SAN FRANCISCO BAY CONSERVATION AND DEVELOPMENT COMMISSION

SUBJECT: James R. Herman Cruise Terminal Project – Piers 27 - 29, City and County of San Francisco – Third Review
(For Board consideration on January 9, 2012)

OPTION 1: Previous Planter Design reviewed by Board Oct. 7, 2011; Consistent with SAP policies

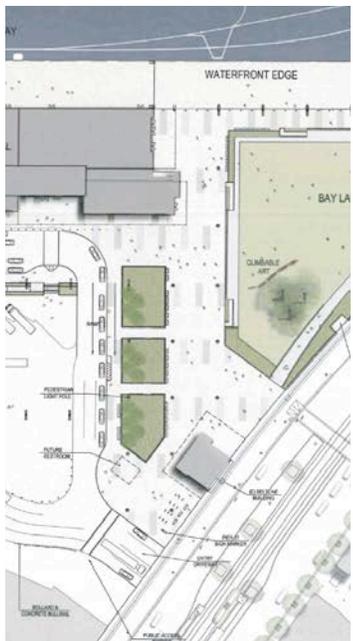
- Whether the design options for the planter area dividing the GTA from the Plaza provide for passive uses and accommodate intimate seating options (see Exhibits, pp. 10-13). Are there specific design ideas for this area that would allow for passive, sheltered or quiet gathering spaces providing a different experience than that programmed for the large Northeast Wharf Plaza lawn?

Design Options for Planter Area Dividing GTA from Plaza
